30/13-00B 4710 Waverly Avenue  
(Garrett Park Historic)

## Changes to Plans for

4710 Waverly Avenue, Garrett Park, MD, 20896-0424

Permit Number: 232765

RIGHT SIDE  
1/8" = 1'-0"

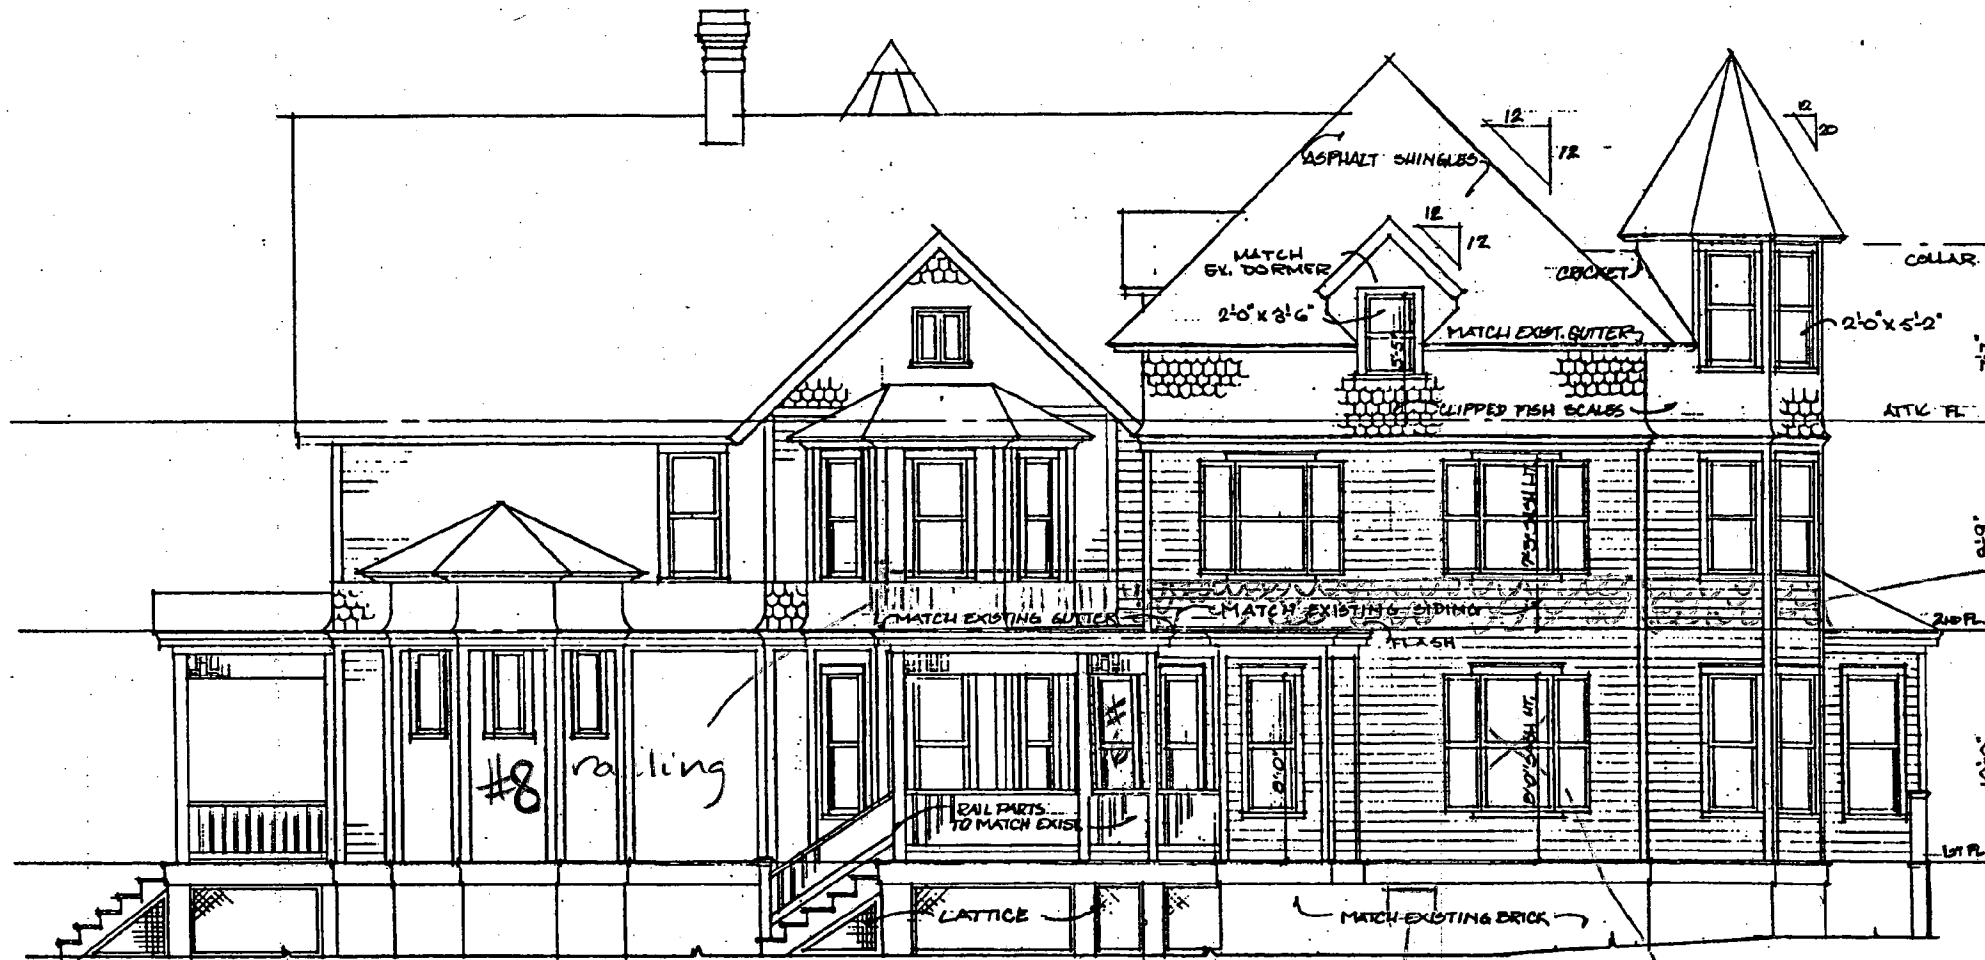
5. A basement window on the right side is needed for cross ventilation to the basement door.
6. The architect incorrectly removed the door access from the existing house to the new bedroom on the right side of the addition. See the 6'7" wall shown on Circle 11 in

#5 basement window

#4 no window

#1 clipped fish scale

*Approved @ Staff level*

*needed HAWP*

page 6R (There is no page 7R since front and rear elevations are on one page.)

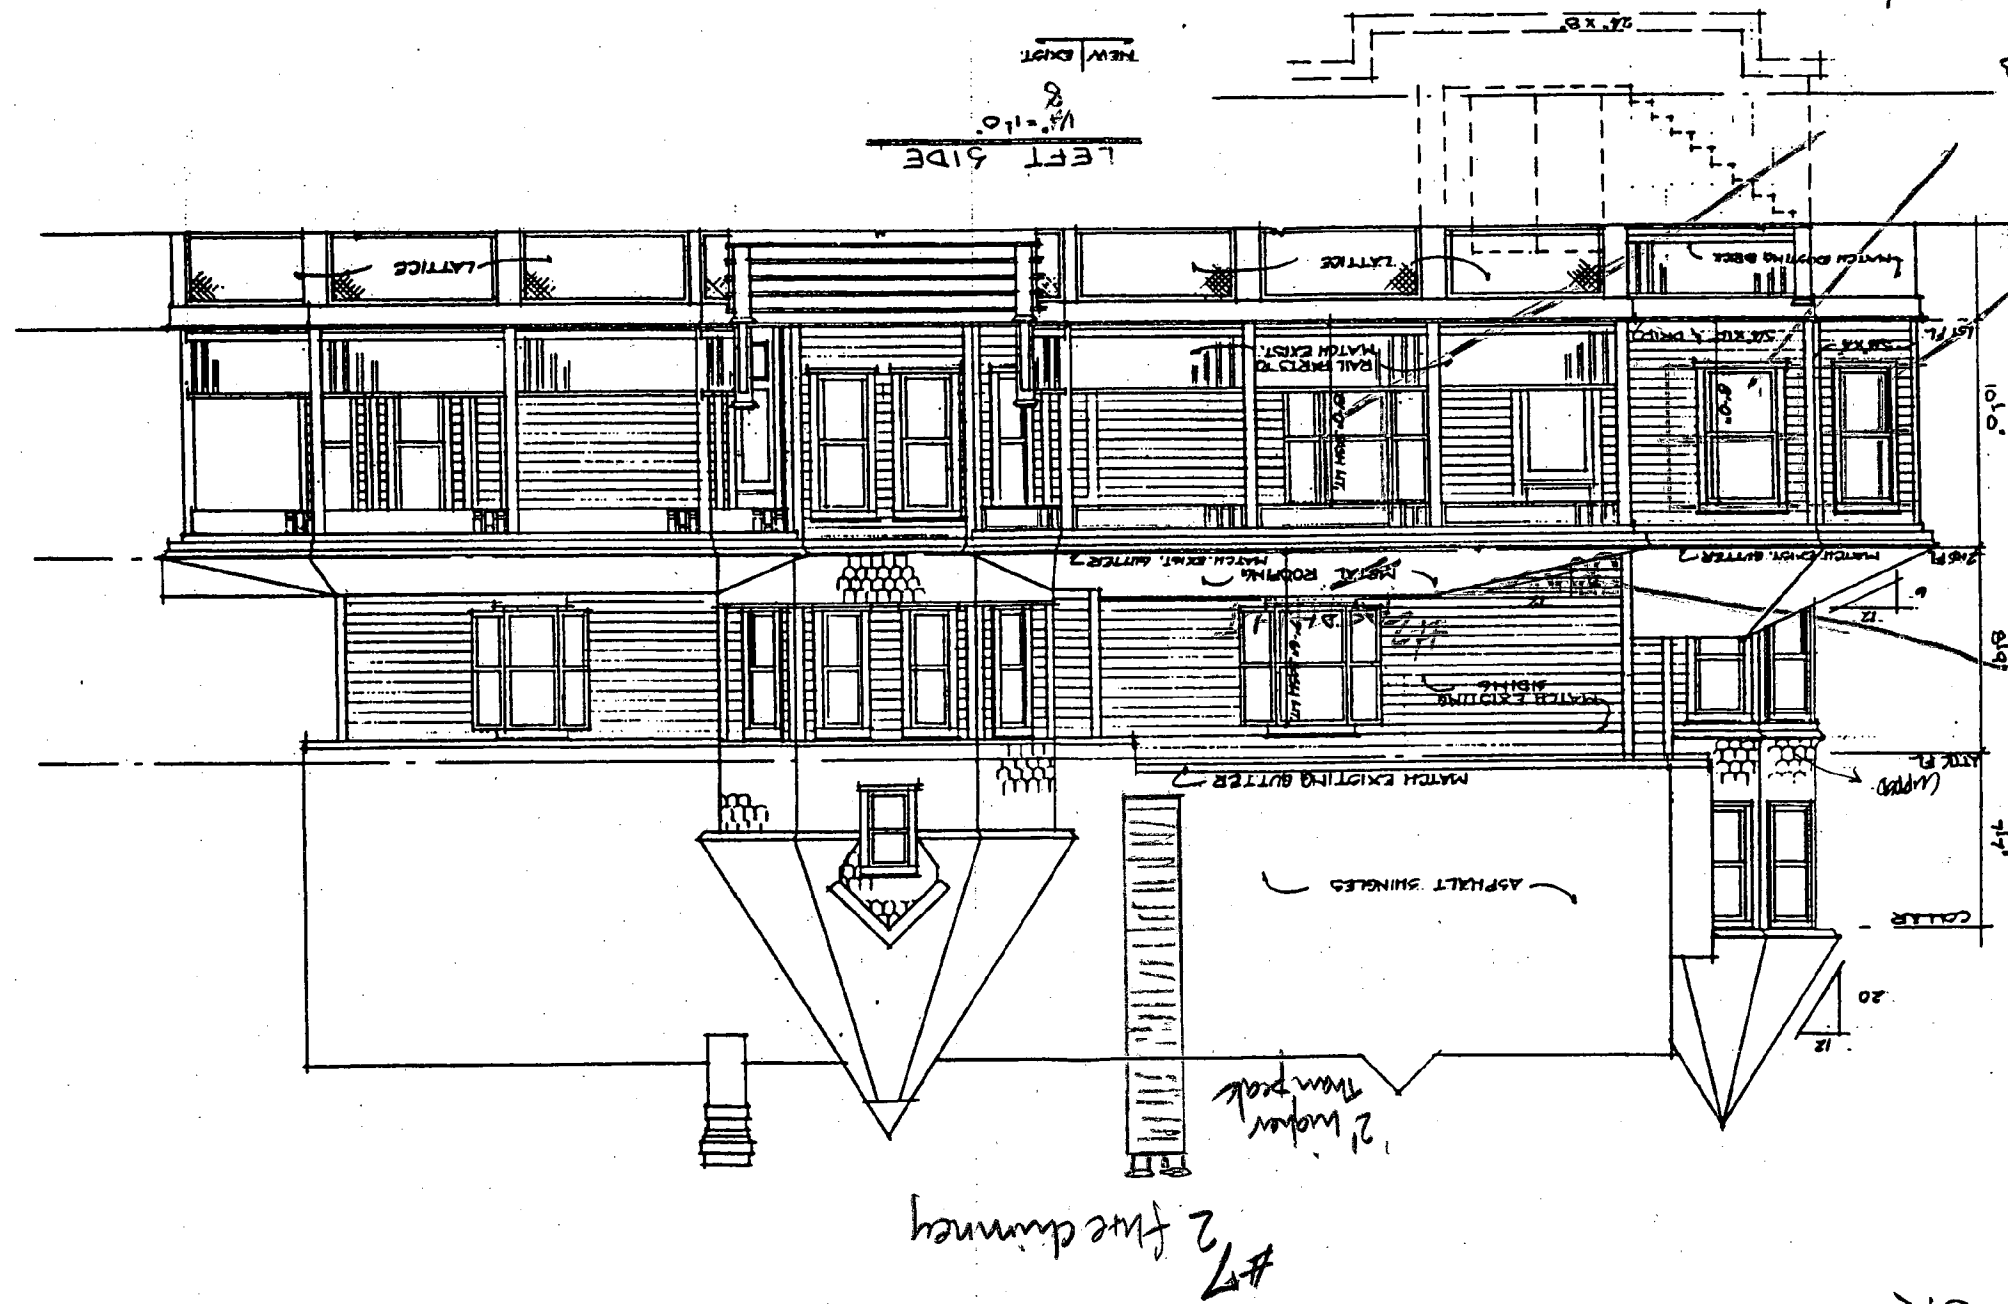
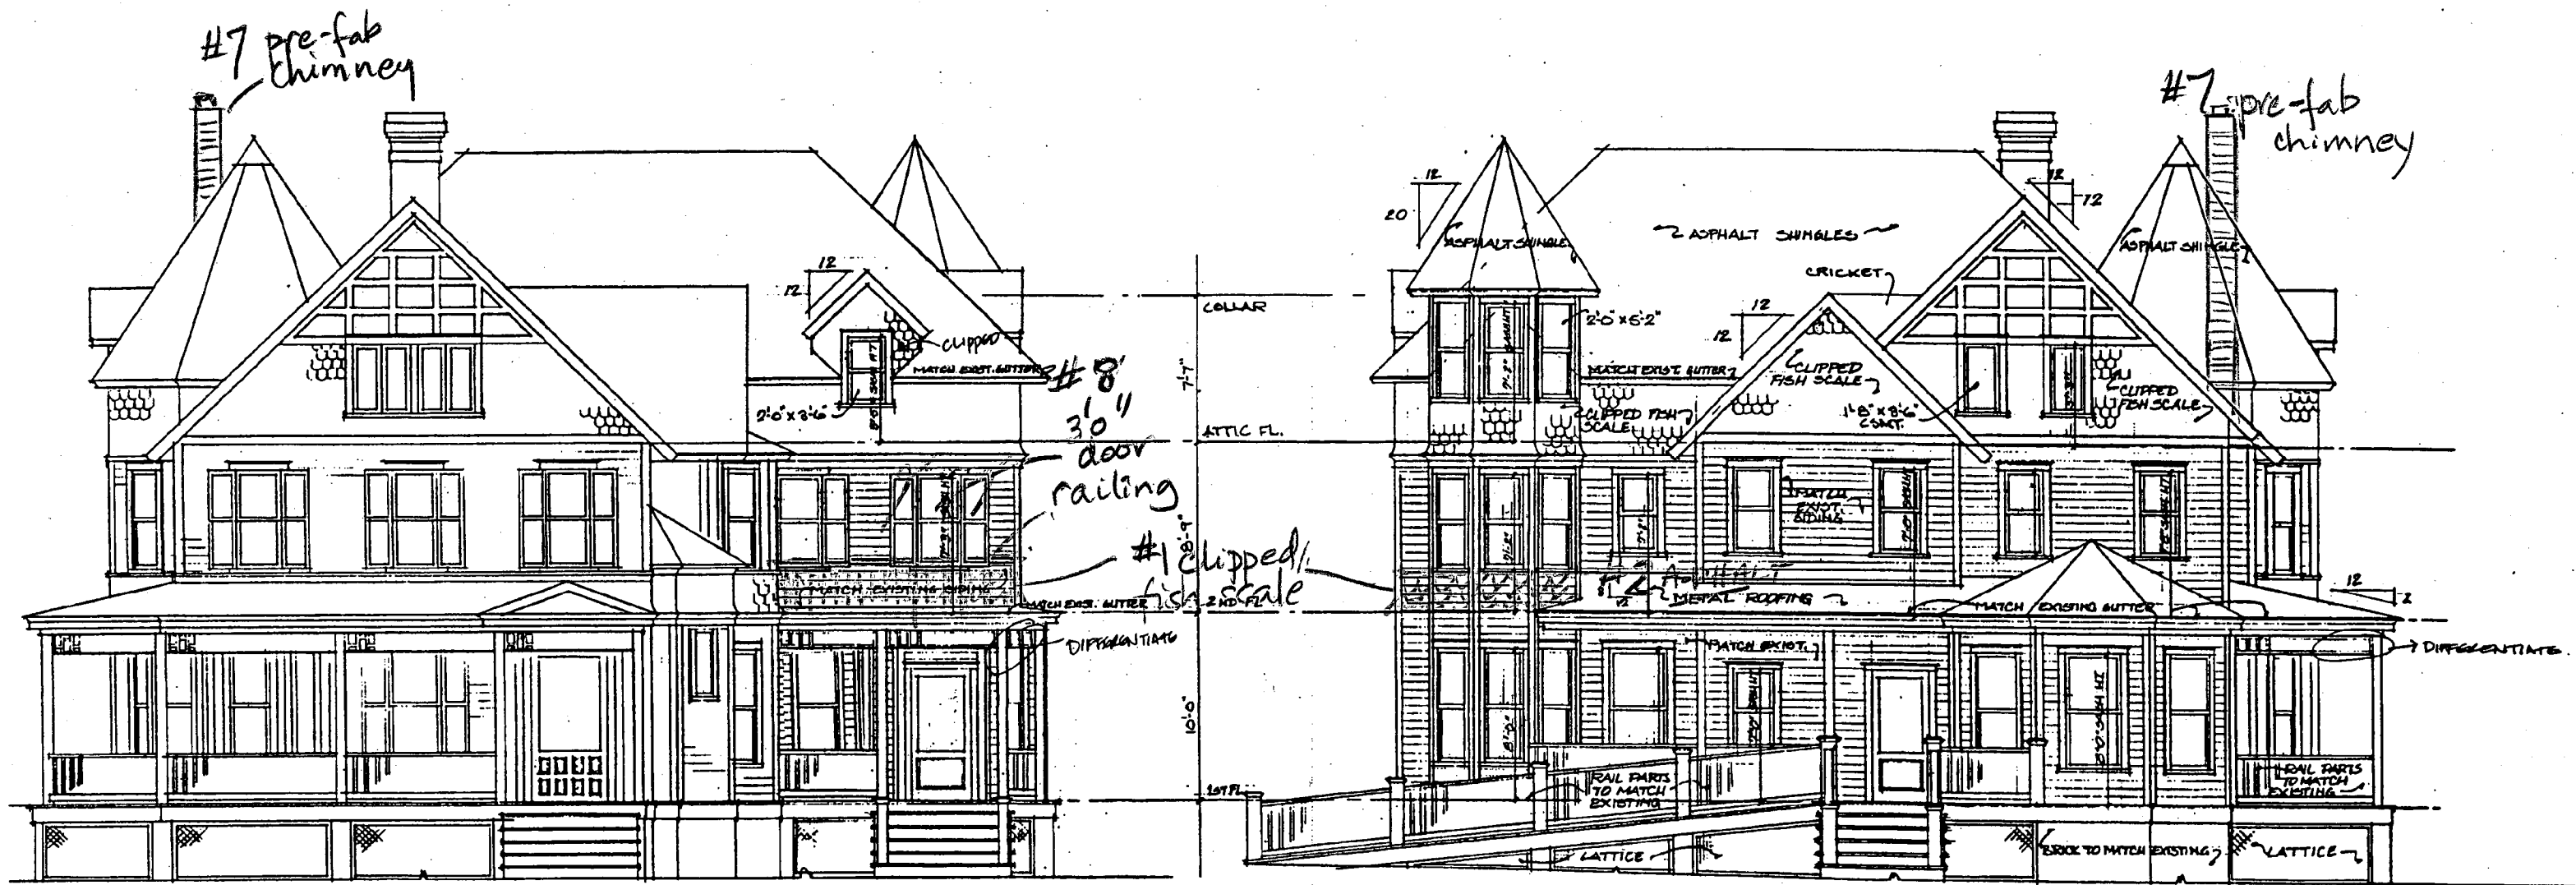
#3 Pella double hung  
(call new windows)

#4 larger  
windows

#1 clipped  
fish  
scale

FRONT ELEVATION  
1/4" = 1'-0"

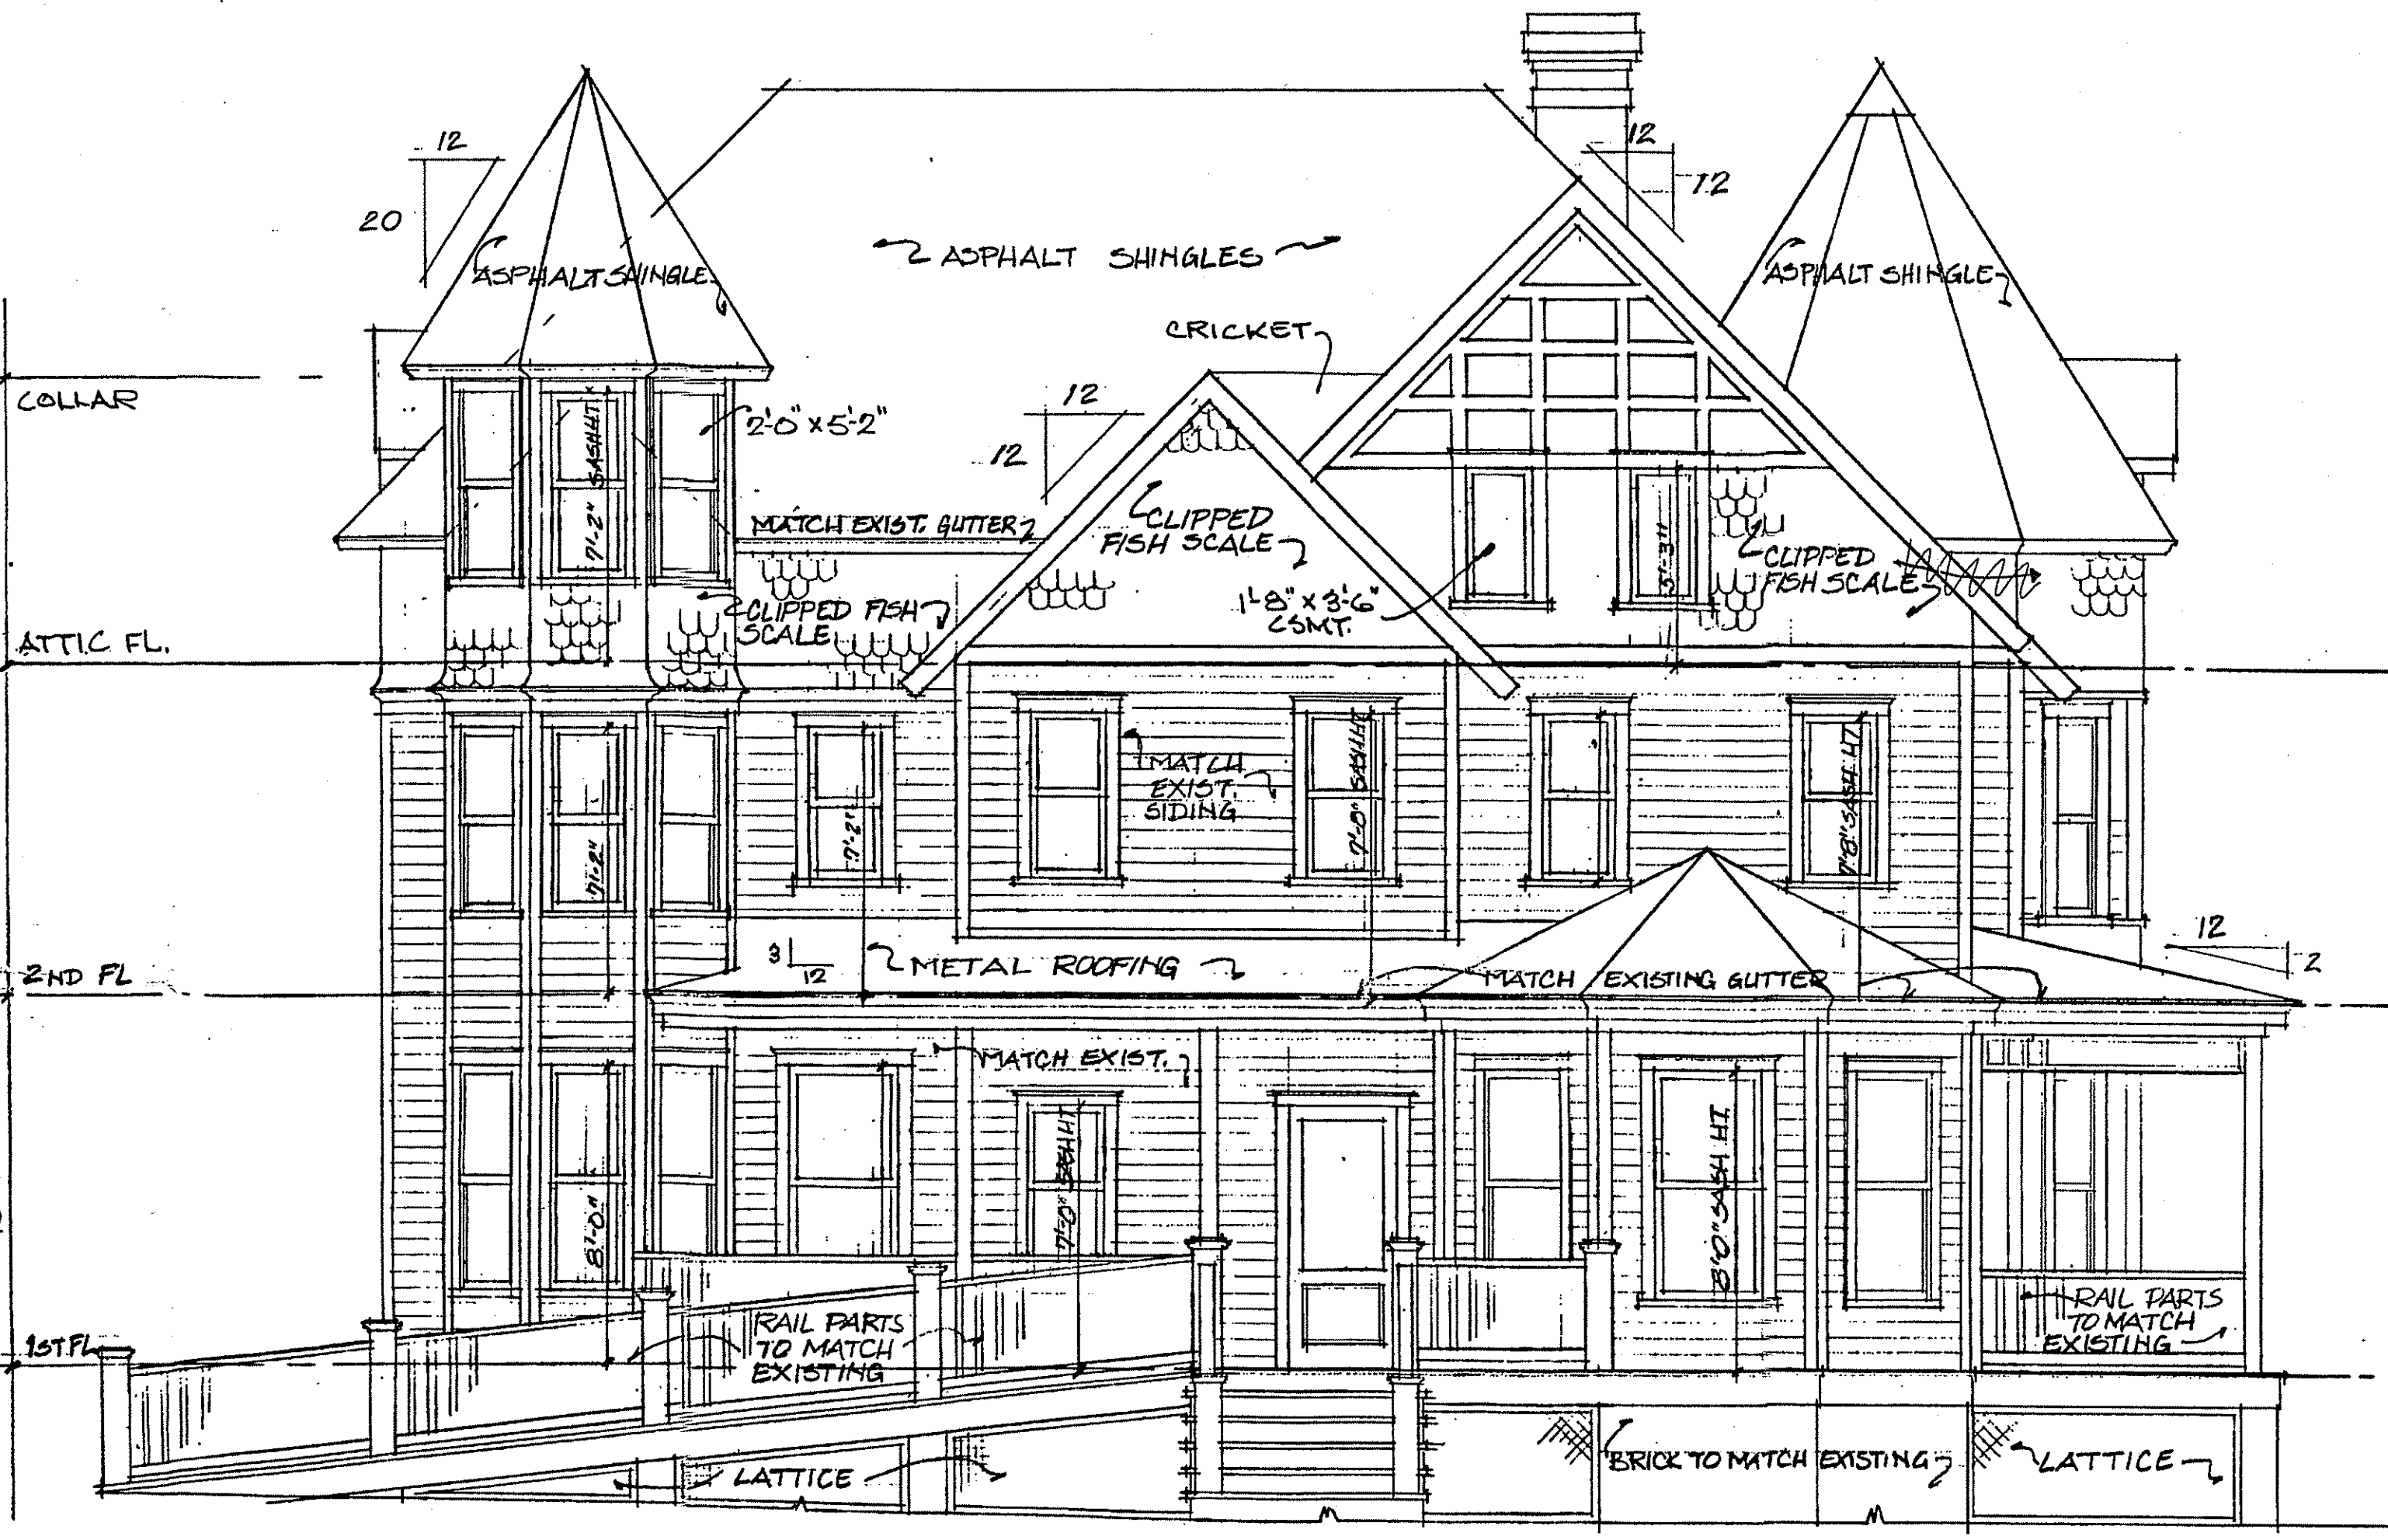
NEEDS TO BE DIFFERENT DESIGN FROM FRONT ORIGINAL.
